Subj: COLLAPSED STORM CULVERT UNDER A/C PARKING APRON, MARINE CORPS AIR
STATION, NEW RIVER, NC

Encl: (1) Sketch SK-C-170-84

LANTDIV, NAVFAC-ENGCOM, NORVA
TEMPORARY CULVERT RECOMMENDATIONS

26 JUNE 84, RLT
 SK-C-170-84

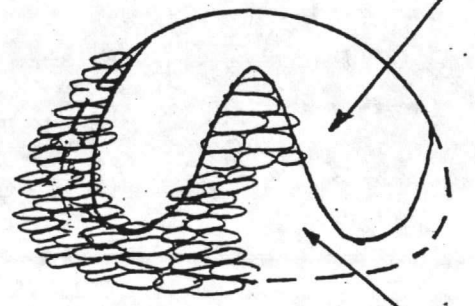
2. The 12'-8" x 8'-1" Armco multi-plate pipe arch culvert has collapsed from the bottom up, in the middle, forming a horseshoe shape. See section on enclosed Sketch SK-C-170-84. It was the consensus of opinion that the failure was caused by the build-up of hydrostatic pressure collapsing the multi-plate pipe arch at its weakest point; the bottom center seam. Approximately 700 LF of culvert is damaged and will have to be replaced, beginning at the inlet end of the culvert. Approximately 610 LF of the damaged culvert lies under the 6" unreinforced concrete A/C parking apron. As of 22 June no visible fractures or subsidence of the pavement was detectable. A profile, elevations at 50' intervals, was taken and plotted on the original construction grading plan with no significant differences. The earth shoulder at the northerly side of the apron has subsided approximately 4 feet. A void area exists under the pavement approximately 3 feet deep by 30 feet wide centered over the culvert. The void exists as far under the pavement as visible. Approximately 390 LF of the culvert at the outlet end was undamaged. Top and bottom flowline elevations were taken in the undamaged culvert and plotted on the original profile. Differences were minor and considered to be within construction tolerances. Replacement of damaged culvert will require demolition and new construction of 6" unreinforced concrete of approximately 45 feet wide by 635 feet long, with exact requirements determined by design and construction requirements. Existing joint pattern is a consideration as culvert is diagonal across parking apron.

3. Sketch SK-C-170-84 depicts recommendations that should be immediately implemented to prevent vehicular or aircraft accidents and damage to the undamaged portion of the culvert. These recommendations were verbally given to Mr. Rouse and Mr. Baker on 22 June.

PROHIBIT ALL VEHICULAR AND AIRCRAFT TRAFFIC FROM HATCHED AREA

NOTE "A": REMOVE INLET END OF CULVERT TO A POINT 25' FROM EDGE OF CONCRETE. SAND BAG REMAINING PIPE END TO PREVENT FURTHER ERDSION AND TO DIRECT WATER FLOW INTO CULVERT.

NOTE "B": PROVIDE TIMBER SHORING AT UPSTREAM END OF UNDAMAGED CULVERT TO PREVENT FURTHER COLLAPSE.
